## SUNDRY NOTICES AND REPORTS ON WELLS

Robinia Draw Federal # 1

30-015-26097

# Copy of Robinia Draw #1 Wellbore Diagram.xlsx

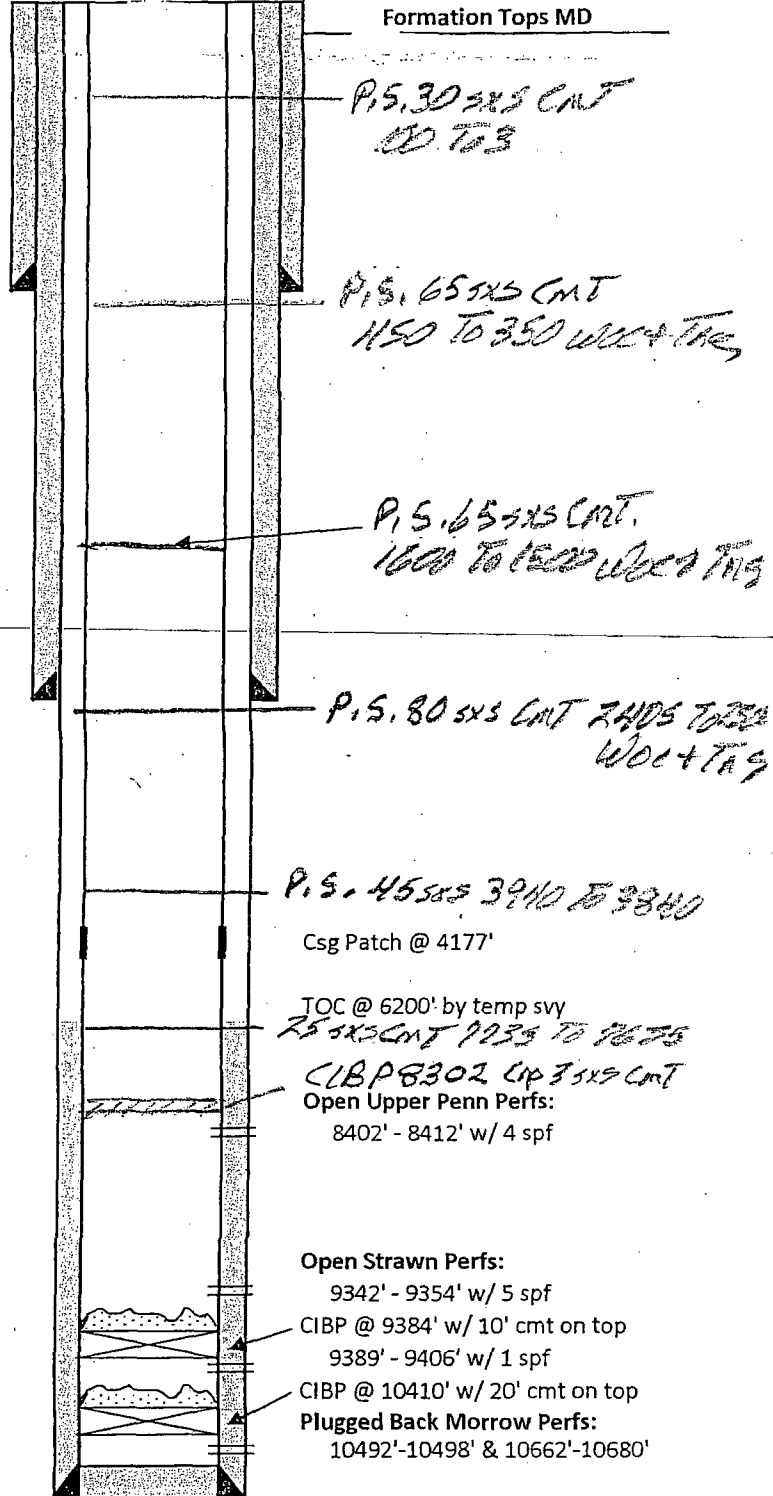
*Add Plug! Set CIBP 9292-9242, cap 10/35' H (Damp bail) or spot 25' 54'*
